# Intel<sup>®</sup> Communications Chipset 8900 Series

Specification Update

*May 2014*

Document Number: 328000-005US

**Figure 2. 1000BASE-BX/FC-PI Transmitter Electrical Specifications**

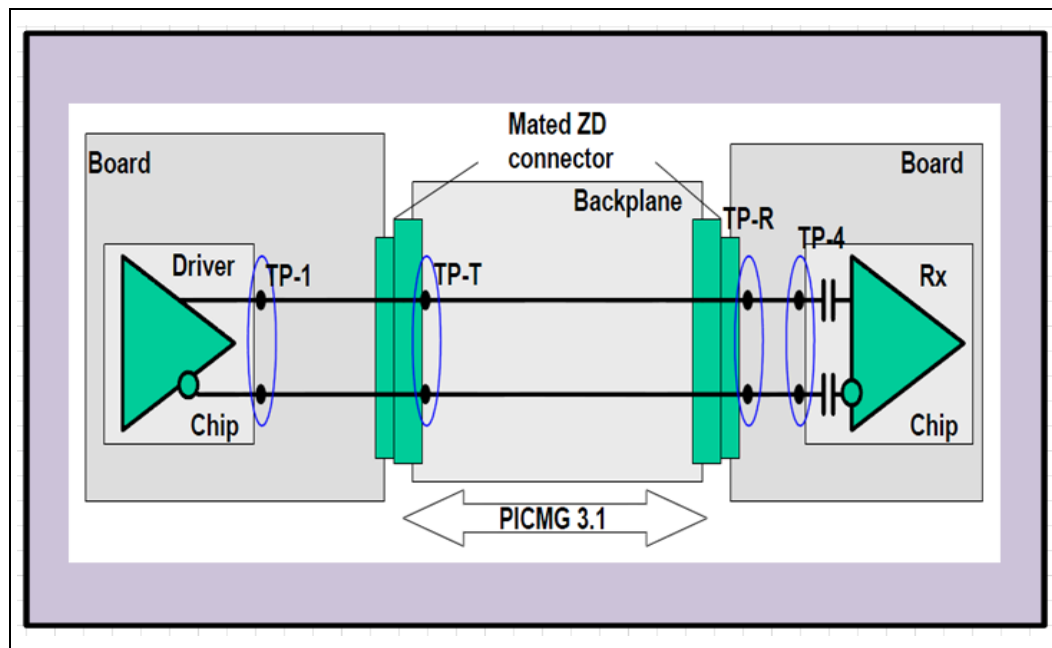
**Implication:** Although this is a specification violation, it does not affect the functional operation of the interface.

**Workaround:** Ensure that the signal routing length from TP-1 to TP-4 is greater than 10". Refer to *Intel® Communications Chipset 8900 Series Platform Design Guide (PDG)* for maximum routing length. (See [Figure 2.](#))
